Addendum No. 2 to IFB 18-06

To: All Parties on Record with the City of Somerville as Holding IFB 18-06,
2017 Street Resurfacing Project

Re: Answer Questions, Append Addition to Scope of Work

Scope of Work Clarification – Cedar Street

C3.0

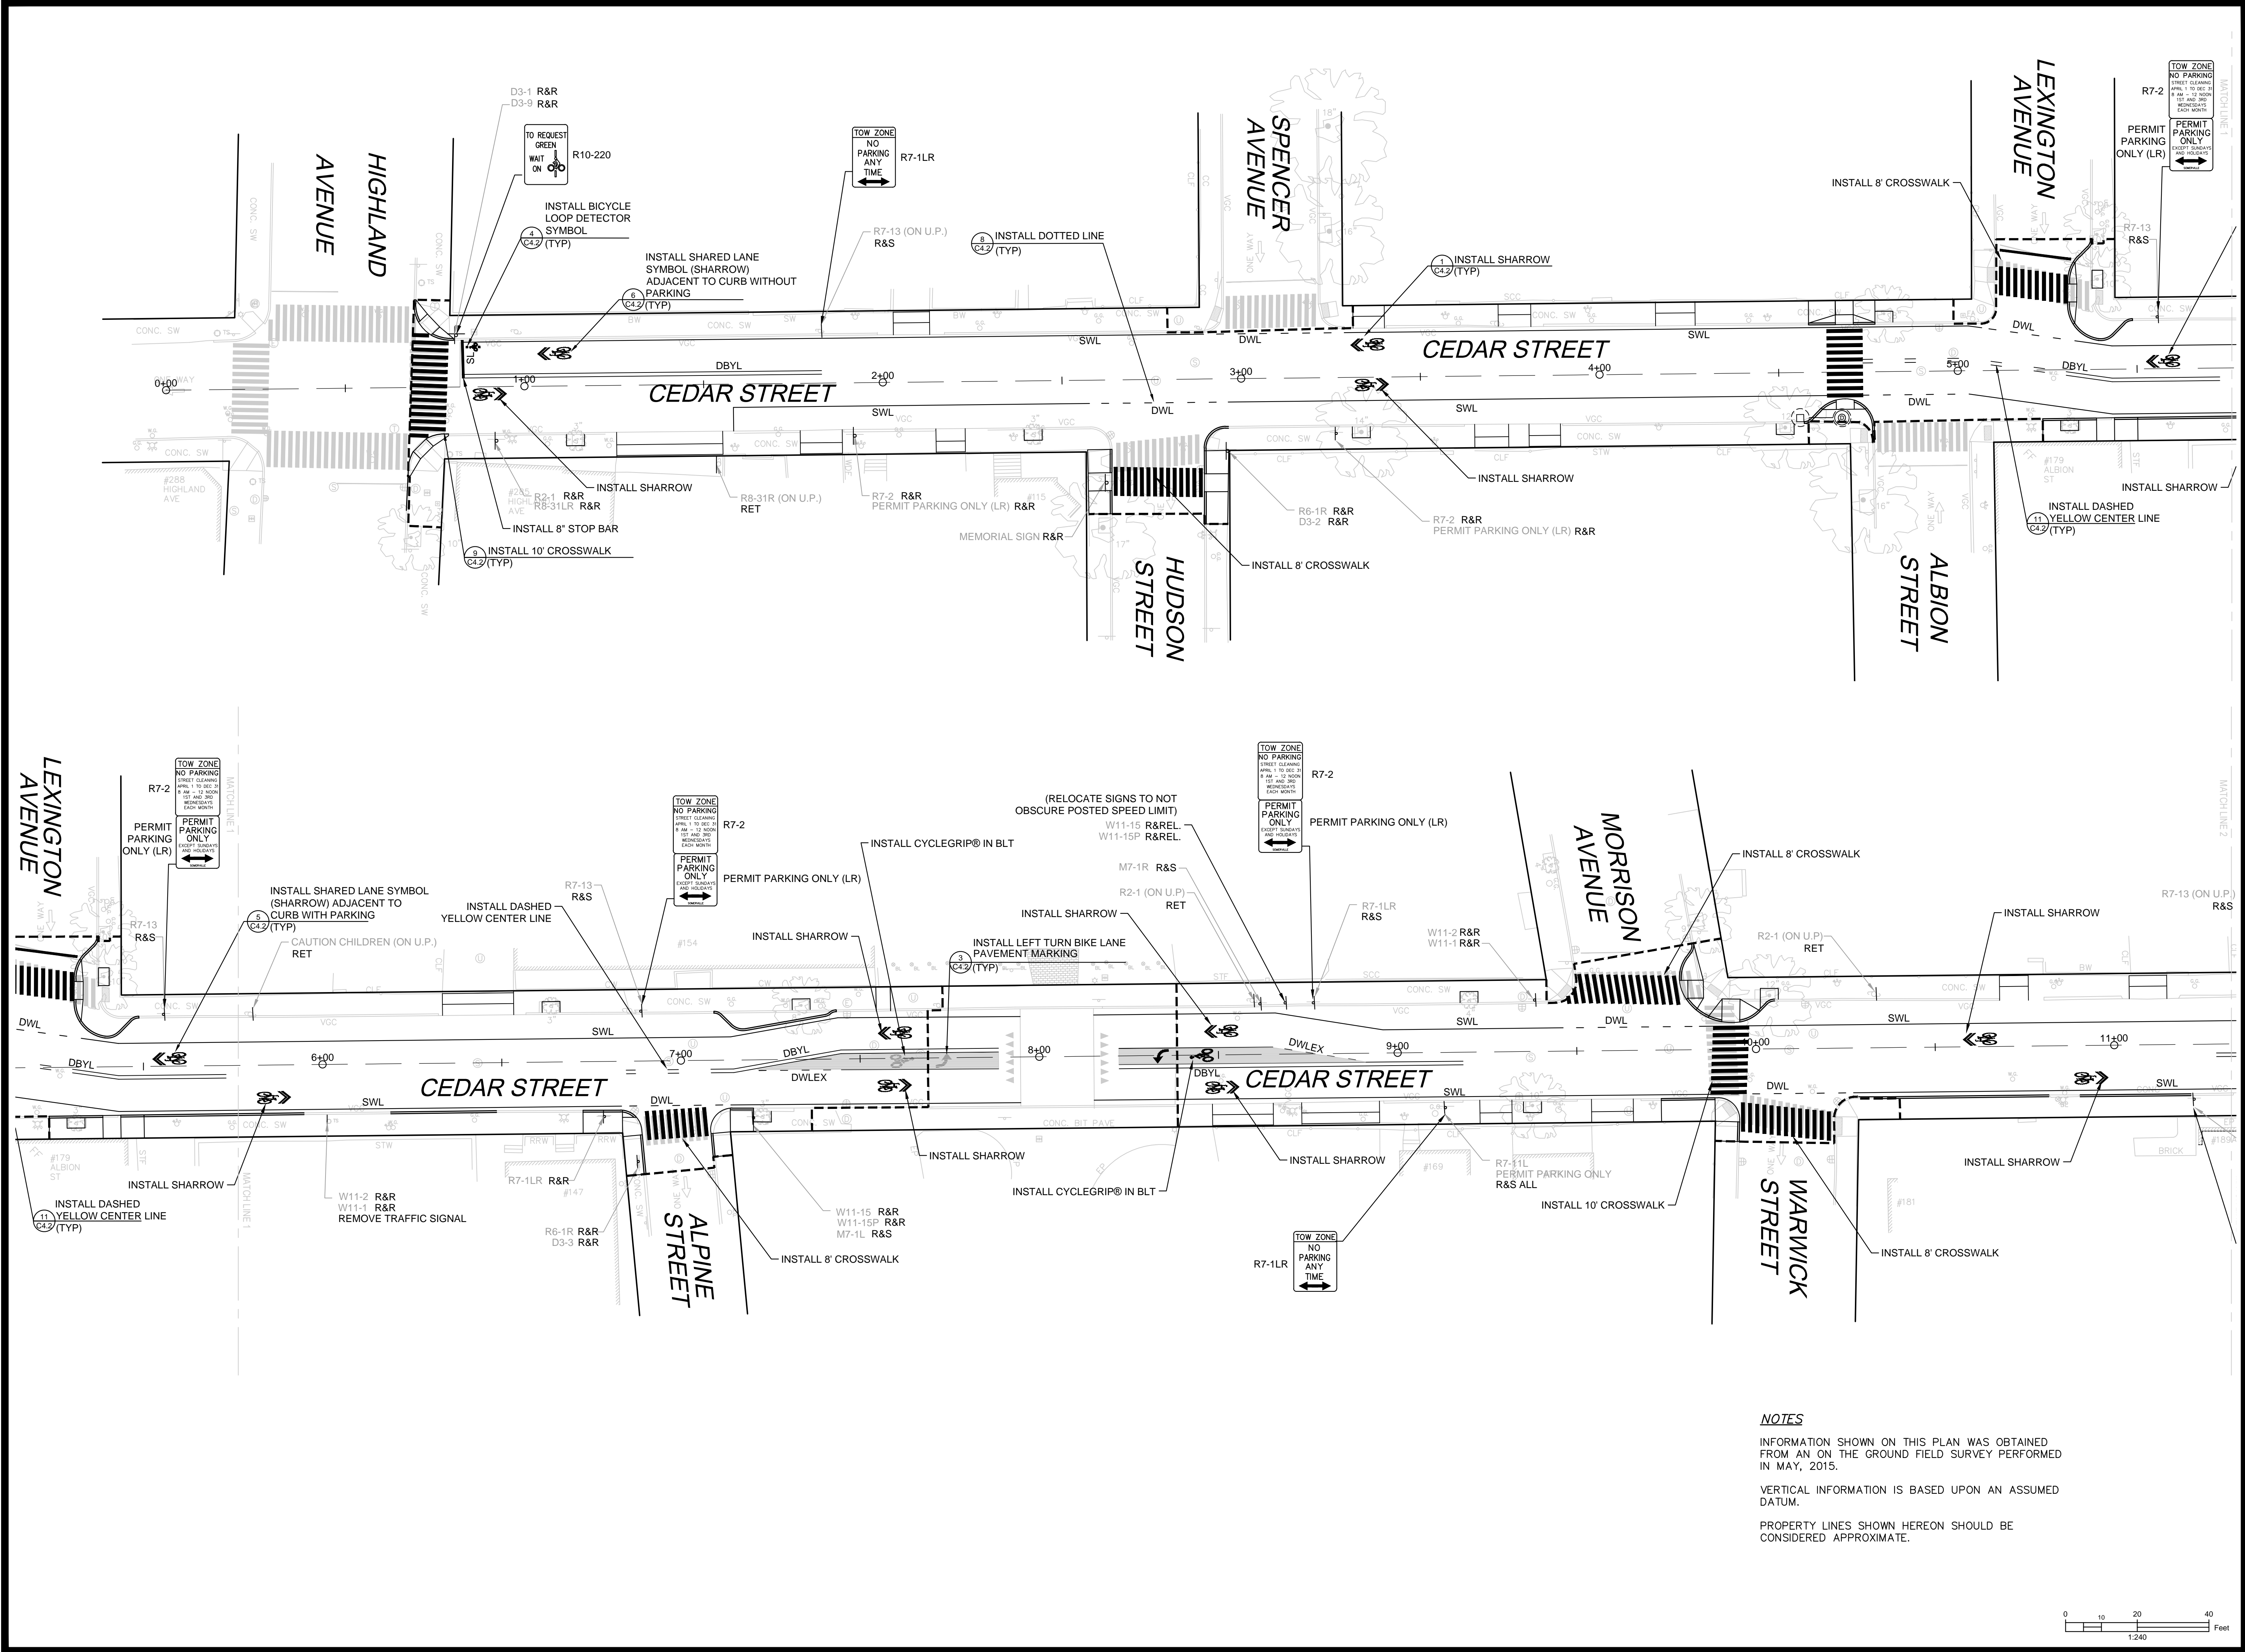
Cedar Street curb alignment and striping shall be constructed according to the attached plan. Quantities on the current bid form reflect the changes from existing conditions.
